ORDER UNDER SECTION 96 (2) OF ACT, III OF 1901.

With reference to his application, dated 15th April 1918
 Mr *Bhaji D. Newandram* is informed
 that the plan submitted by him for building a *lungalow*
 on plot No 19^a, Survey Sheet 711
 situate in *Sea Field Road Civil Line*
 Quarter, is approved, and permission to build in accordance therewith is
 granted. The building to be erected subject to the By-laws and Rules of the
 Municipality.

SHOWING PROPOSED BUNGLOW
ON PLOT NO 192 SHEET FII
CIVIL LINE QUARTERS
SCALE 1/4" = 1' INCH

PLAN
SHOWING PROPOSED BUNGLOW
ON PLOT NO. 19A SHEET FII
CIVIL LINE QUARTER
SCALE 8 FT = 1 INCH

OF OUT-HOUSES & KITCHEN ON SUNNY-

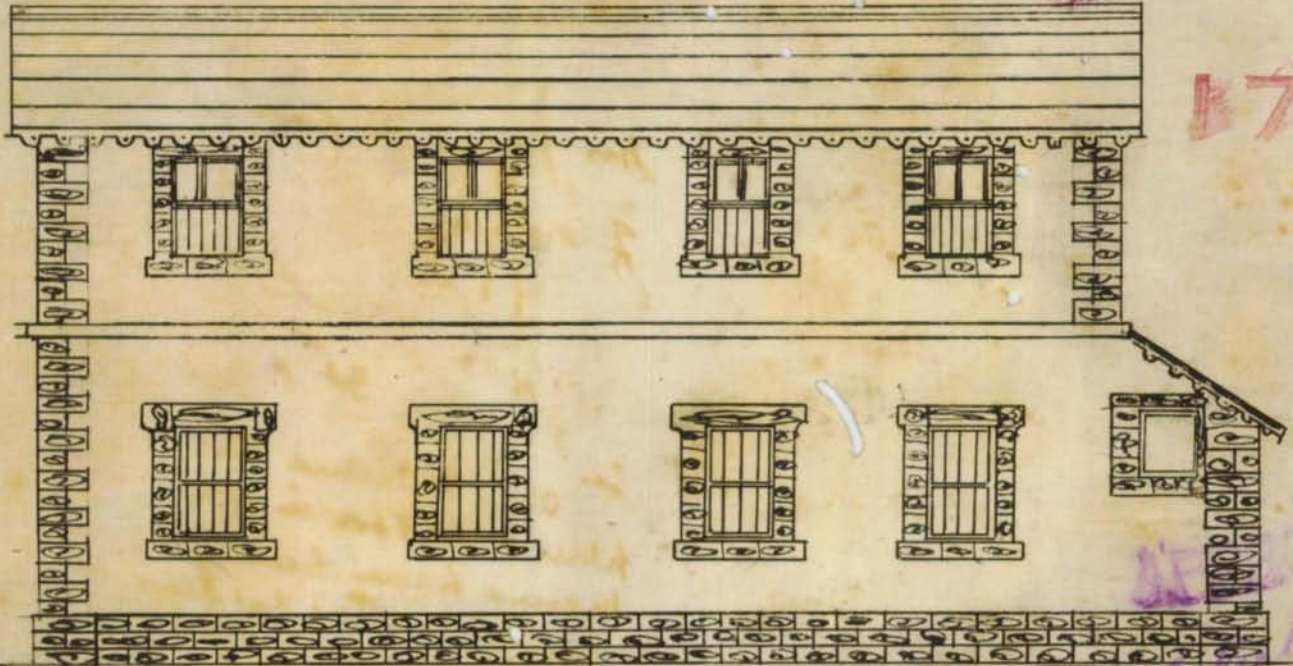
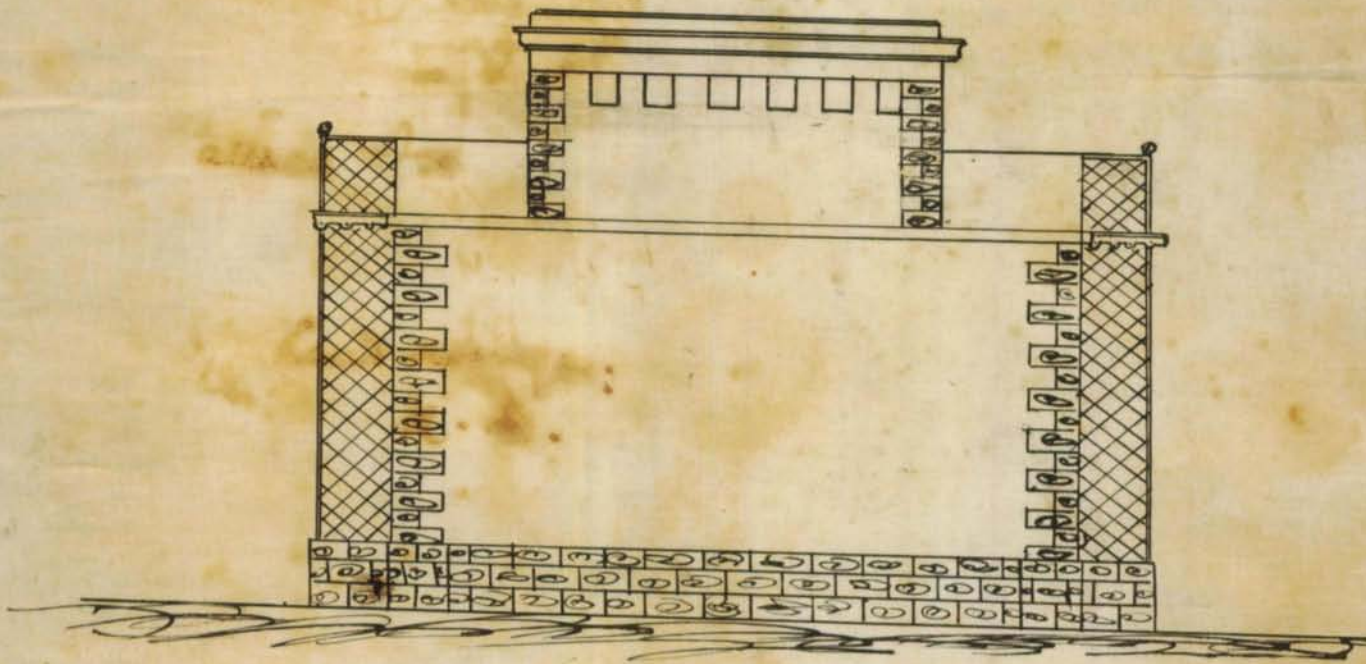
With reference to your No: 651 dated 17th
20
July 1918 I beg to submit herewith Elevation of
out-houses and kitchen from the sunny side road
for approval. d e

With reference to his letter dated 24th June 1918 Mr. Durgdas. B. Advani on behalf of the owner of plot No. 19A. F-11 Civil Lines quarter is informed that there appears to be no objection to the plan as now submitted, but an elevation of the out-houses and kitchen ^{from} the sunnyside Road should be submitted for approval. The formal sanction will be given after the plans have been approved by the Managing Committee.

Inform the owner that
there appears to be no objection
to the plan as now submitted,
but an elevation of the
out houses & kitchen from
the Sunjaid Road should
be submitted for approval.
The formal sanction will
be given after the plans
have been approved by
the M.K.

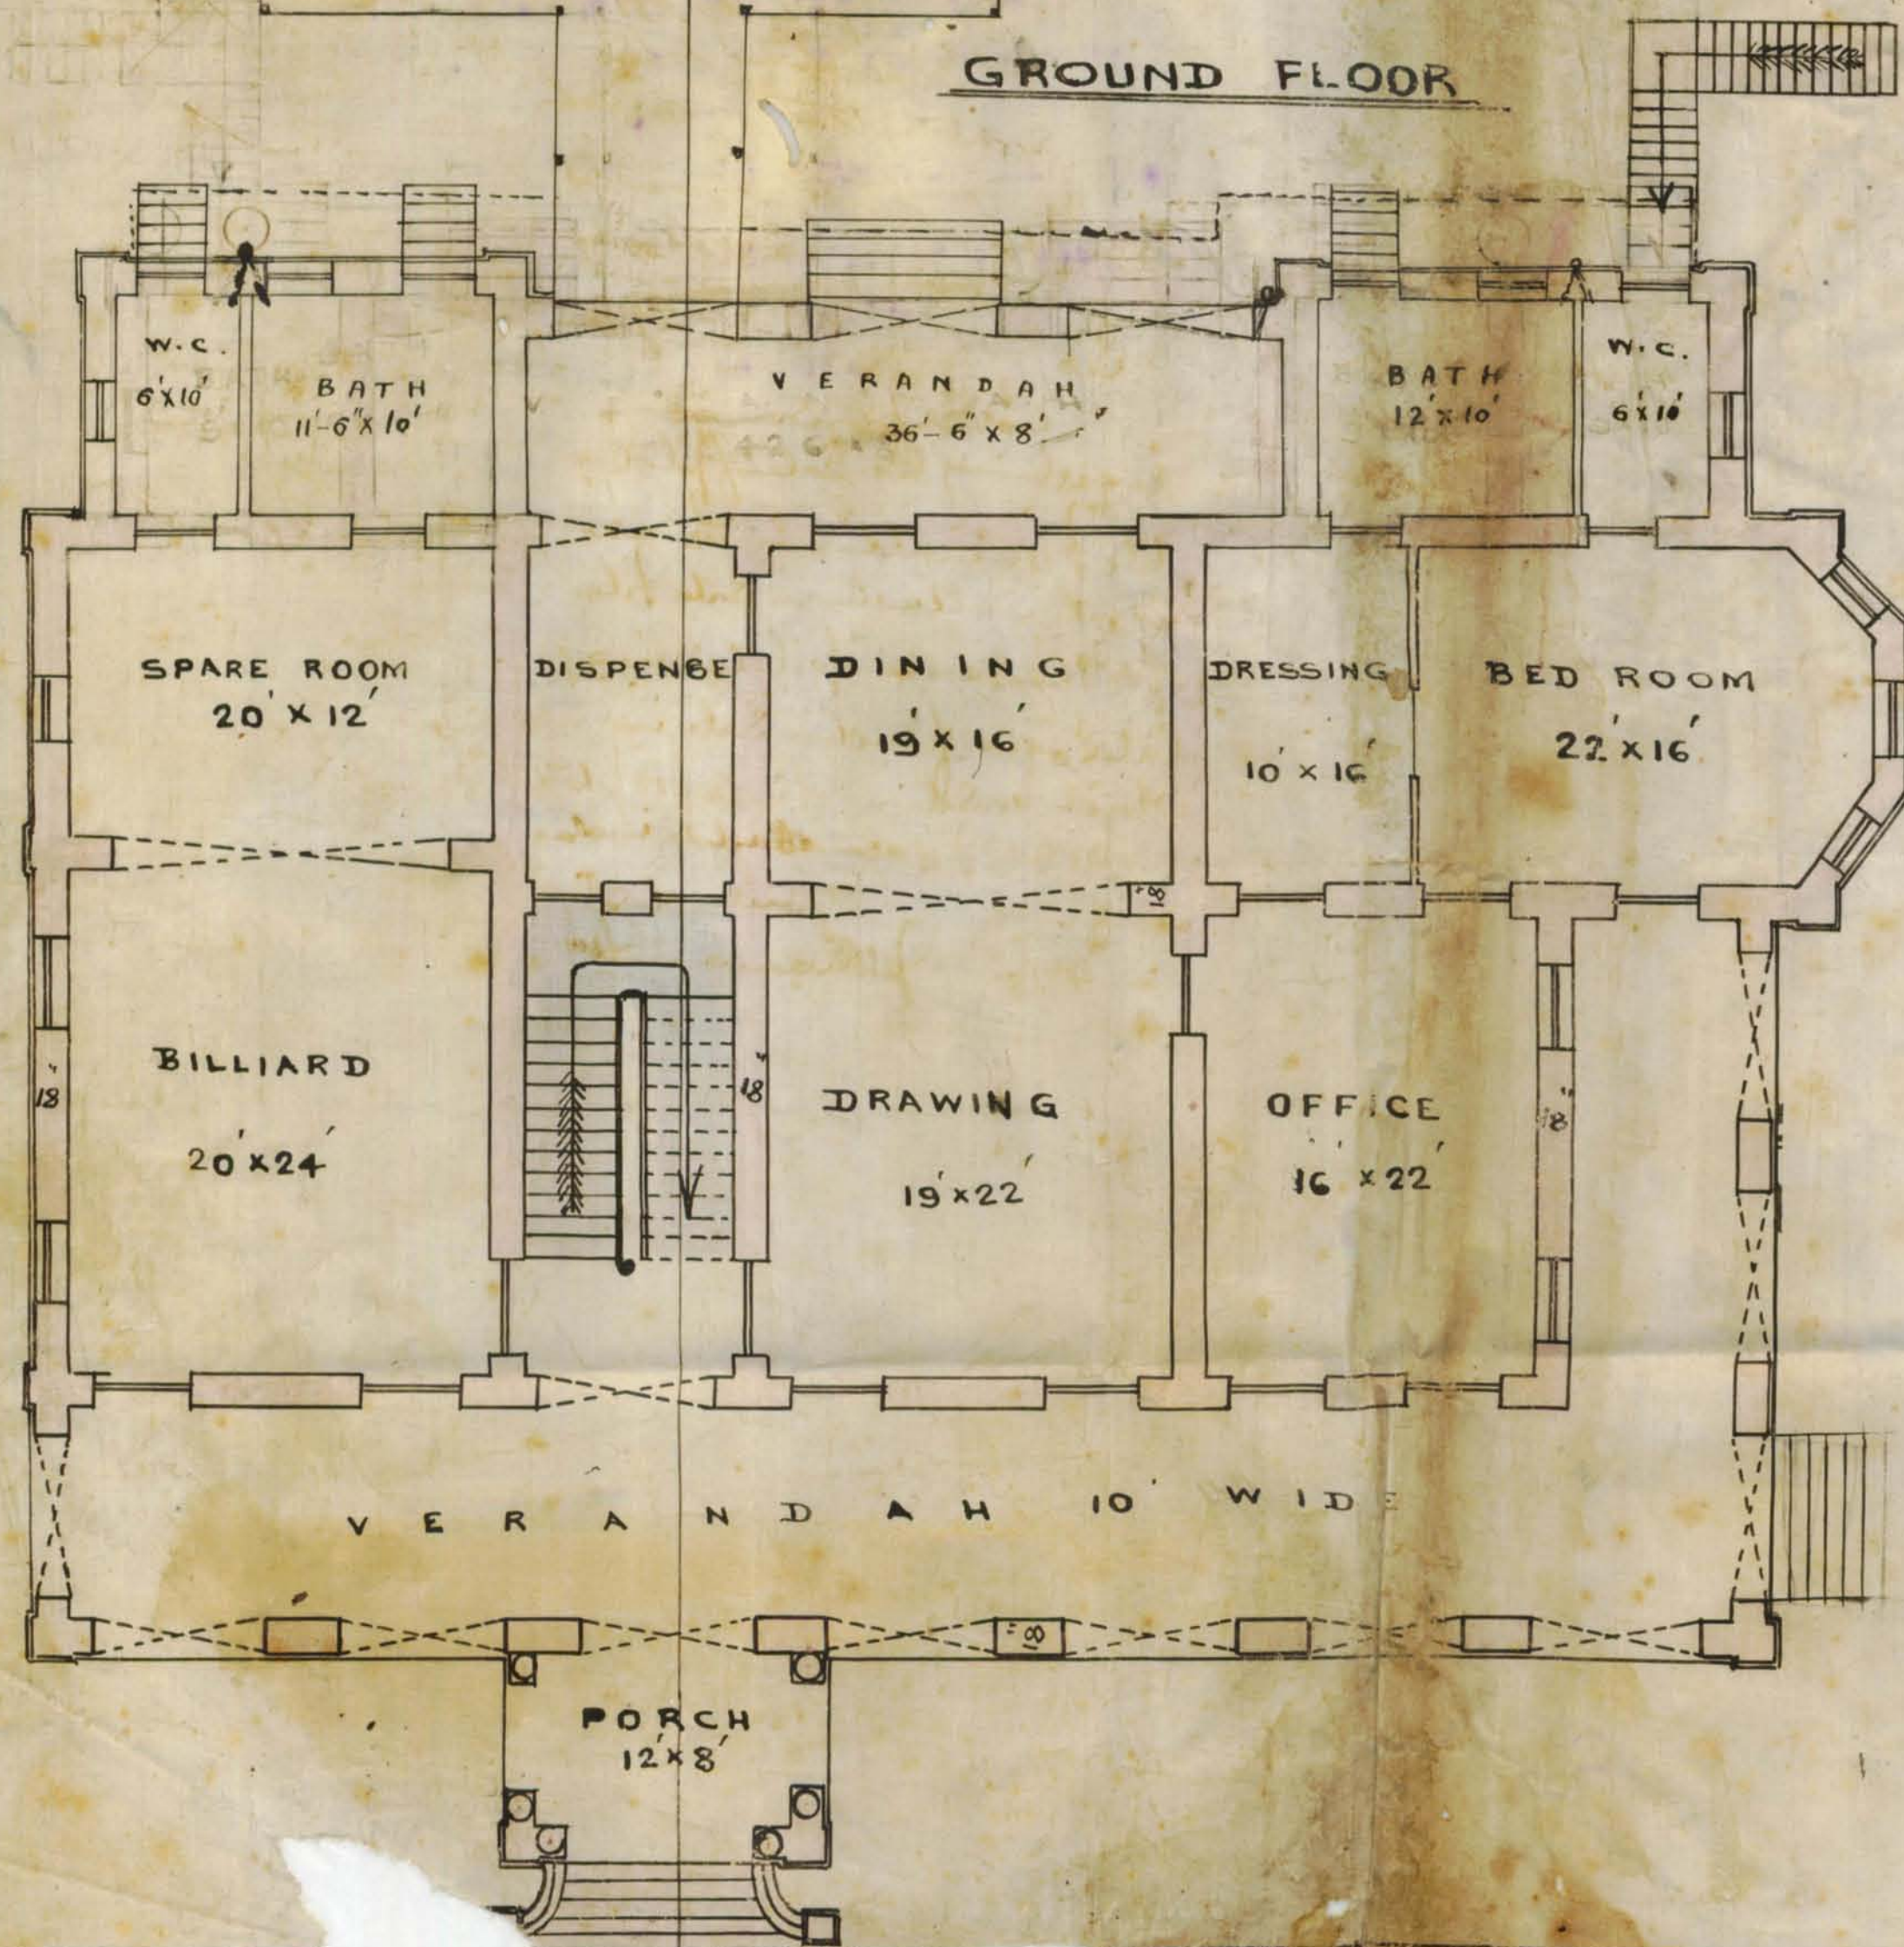
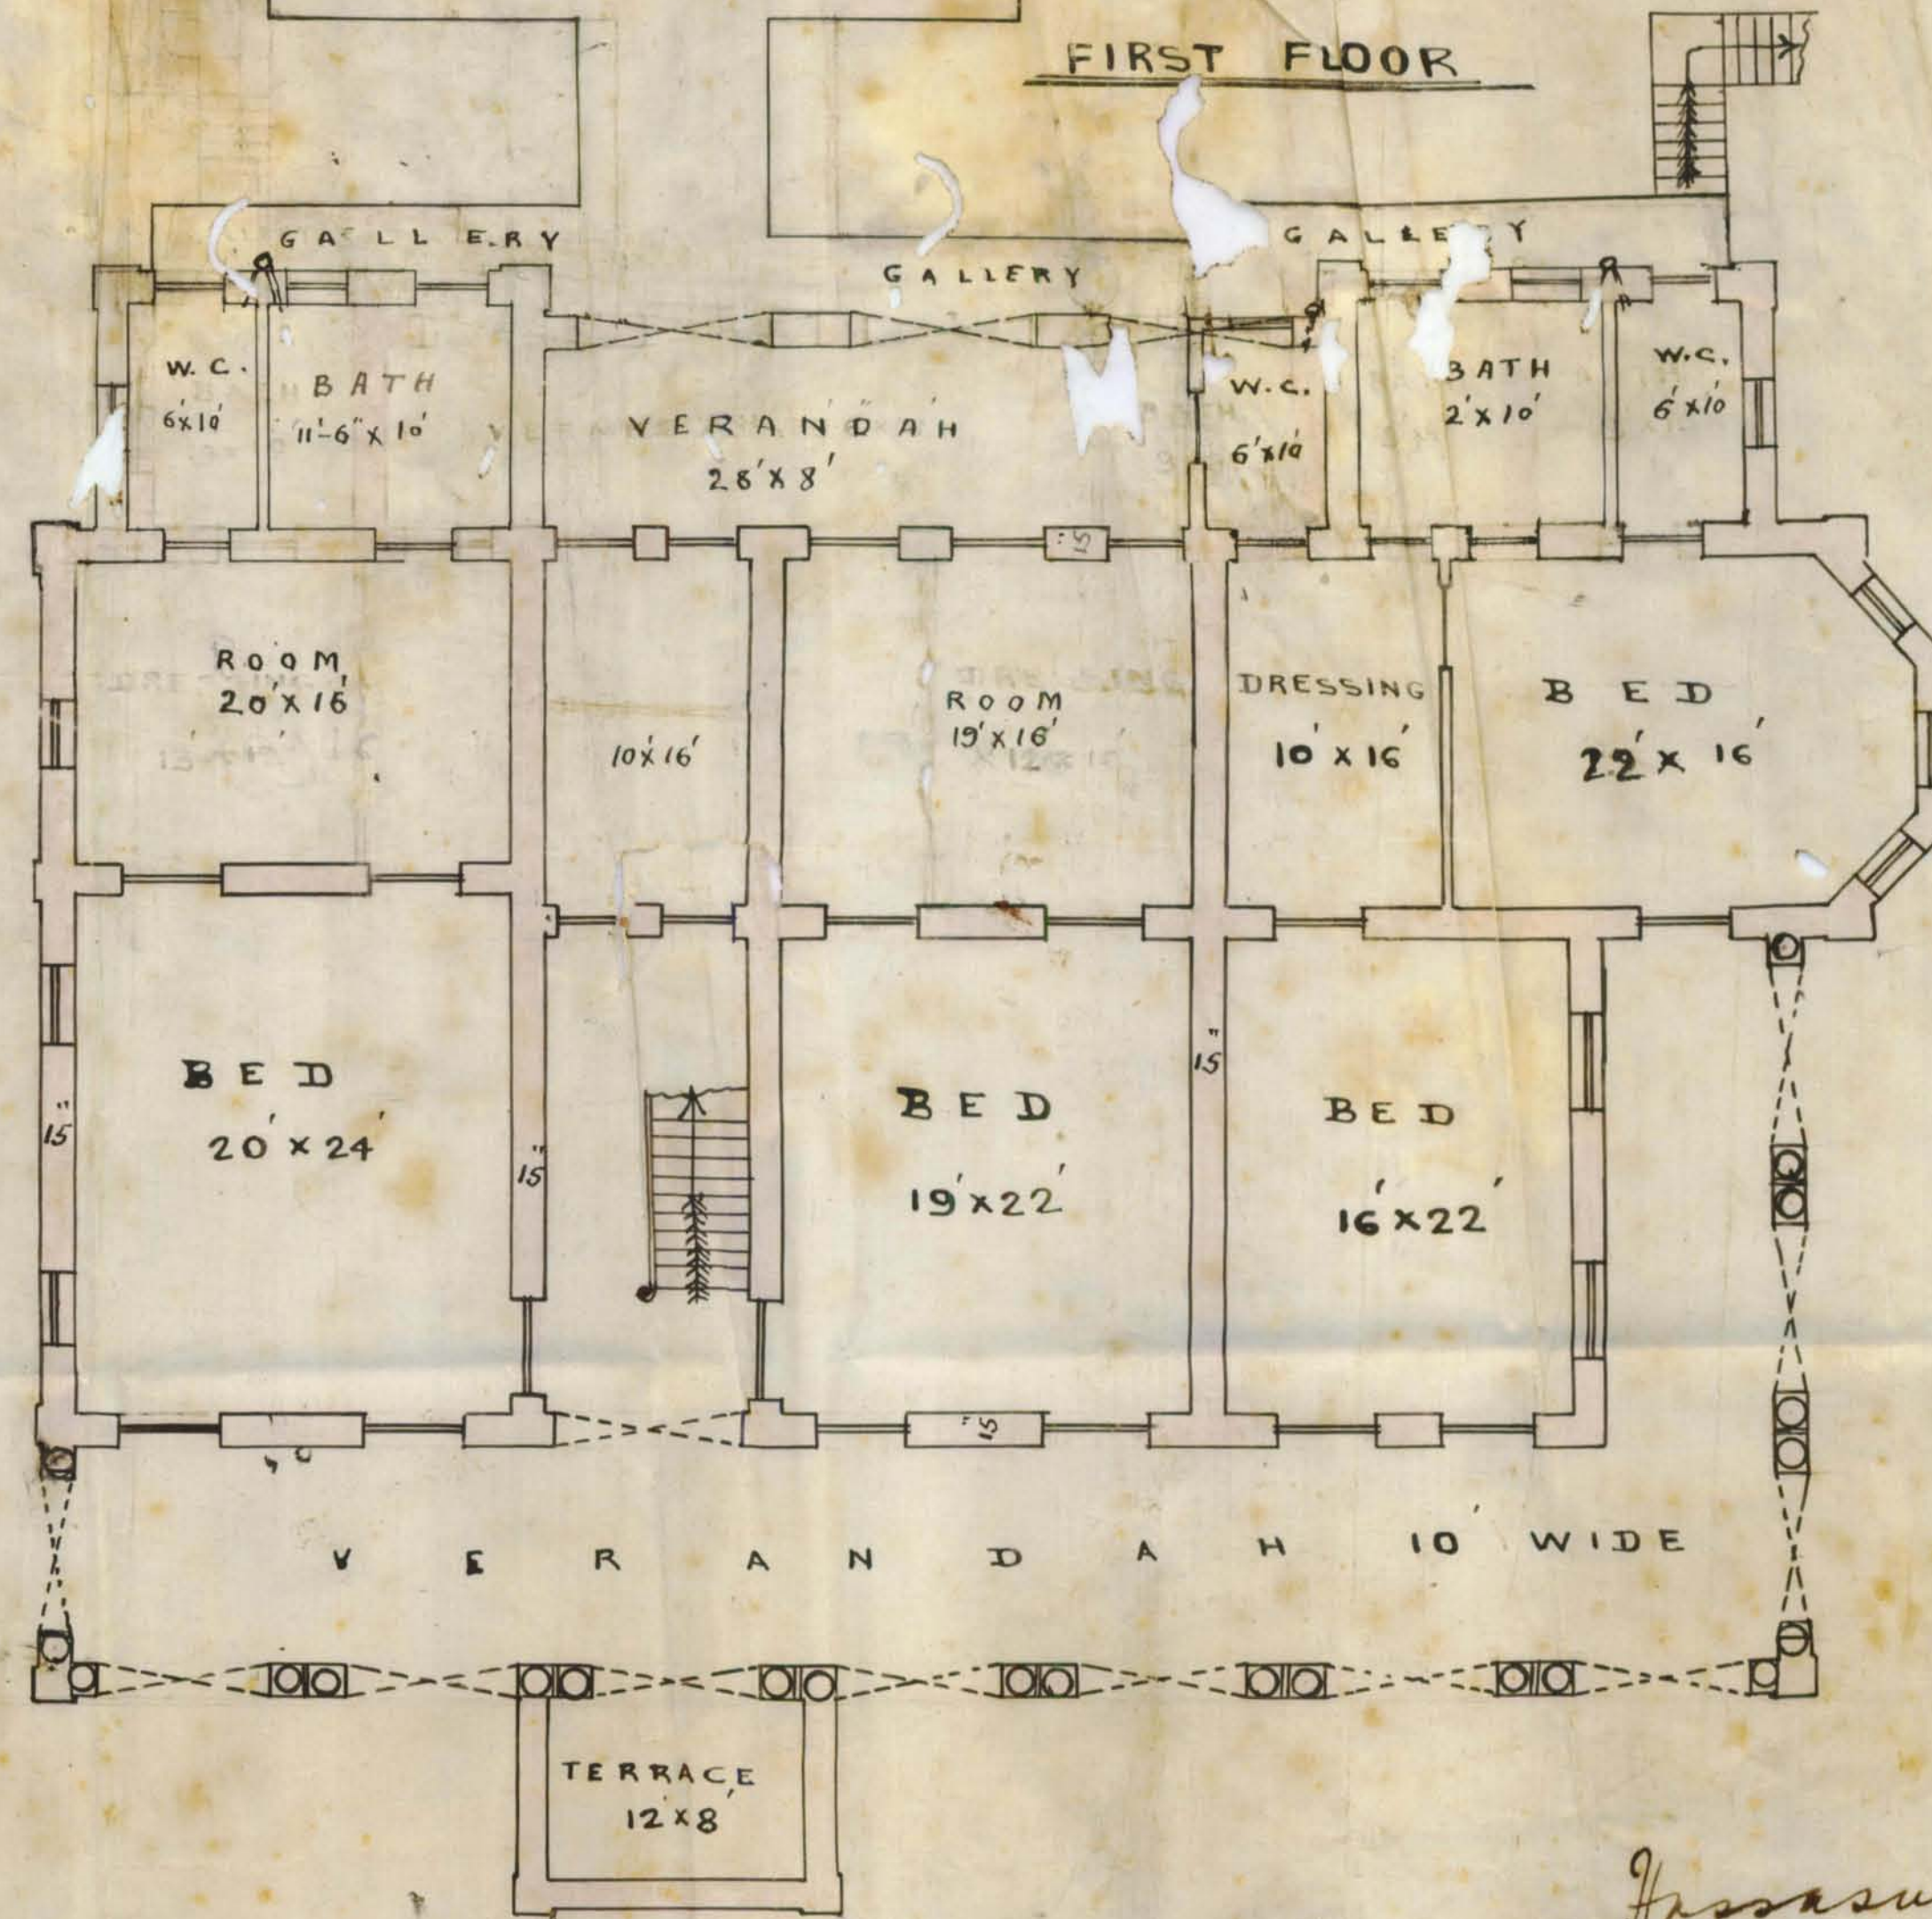
The plan shows quarters etc for a four tenement
building which will not be allowed. If a
single plan for a single tenement structure
is submitted it will be considered. The
plan is disapproved.

With reference to the title deed produced by his Architect in this office in connection with plot No.19A, F-11 17
1 Lines Quarter. Bhojraj Newandram is informed that the plan submitted shows quarters etc. for a four tenement building which will not be allowed. If a plan for a single ~~tenement~~ ^{dwelling} ~~dwelling~~ is submitted it will be considered. The plan is ~~not~~ approved and returned herewith for amendment.
